Development / Project Name	KLA Childcare	
Development / Project Address	Existing: 2857 East Oakland Park Blvd	New:
Legal Description	Lots 6 and 7, Block 17 of CORAL RIDGE GALT ADDITION N0.3, according to the Plat thereof as recorded in Plat Bk 35, Pg 47, of Public Records of Broward Co., FL.	
Tax ID Folio Numbers (For all parcels in development)	494224030510 and 494224030520	
Request / Description of Project	Change of use approval to day care and installation of outdoor play area.	
Total Estimated Cost of Project	\$	(Including land costs)

DEVELOPMENT REVIEW COMMITTEE (DRC) COMMENT REPORT

Request: Site Plan Level III Review: Child Day Care Facility, Large

SHEET NUMBER
C-102

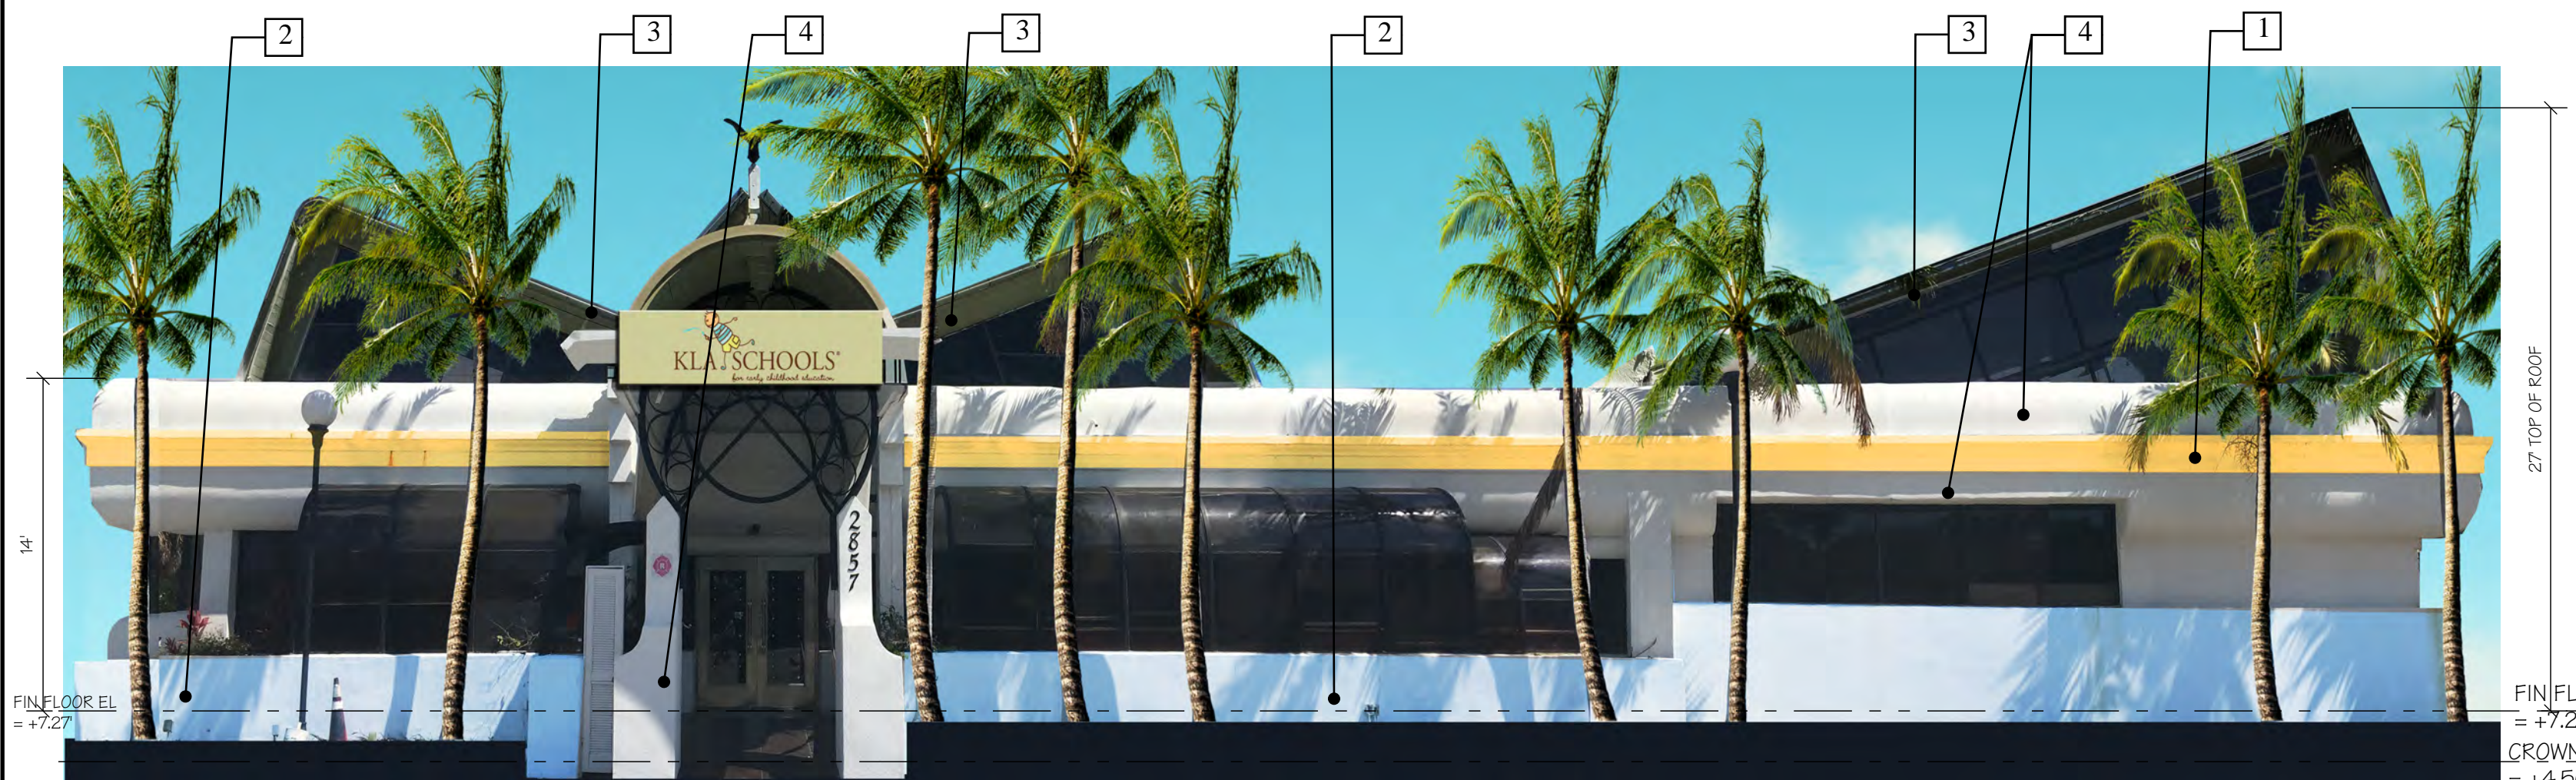
6. Consider relocation of existing Backflow Preventor such that it's closer to the northern property boundary / 20' Alley south Right-of-Way boundary.
7. Sheet C-102: Review potential to provide narrower 12' to 14' driveways at 1-way ingress / egress points to minimize pedestrian / vehicular conflicts, with flare outs internally on-site to meet requirements of ULDR Section 47-20.11. Discuss the possibility of changing driveway access point near southeast corner to 1-way ingress only, and changing driveway access points near southwest and northwest corners to 1-way egress only.

8. Sheet C-102: Discuss possibility of narrowing existing asphalt pavement area, between building and west property boundary, to 12' wide and changing vehicular travel direction to 1-way egress only.

9. Sheet C-102: Discuss possibility of shifting ADA parking stall such that it's adjacent to the Existing Two-Story Building, just west of the Covered Entrance.

10. Sheet C-102: Discuss possibility of widening substandard Drive Aisle widths to 24' adjacent to 90 degree parking stalls: where not labeled but appears to be 20' (East-West Drive Aisle), where labeled 21' (East-West Drive Aisle), and where labeled 22' (North-South Drive Aisle). Near southeast corner of Existing Two-Story Building, consider locating new concrete sidewalk so that it's immediately adjacent (i.e. no gap) to the building, to help with the effort to widen the 21' Drive Aisle.

11. Sheet C-102: Label existing East-West Drive Aisle, just east of Covered Entrance, and extend landscaping island to north edge of Drive Aisle.
12. Sheet C-102: Discuss possibility of shifting proposed Dumpster to where existing ADA parking stall is located (southwest corner of parking lot), converting proposed Striped Turn Around to parking stall, and adding 3'-wide vehicle back-out pavement on north side of North-South Drive Aisle.

13. Sheet C-102: Discuss possibility of providing pedestrian sidewalk access to the proposed development, along SR 816 / E Oakland Park Boulevard Access Road from the existing ADA curb ramp located just southwest of the property (i.e. in raised median island). Coordinate with FDOT as required.
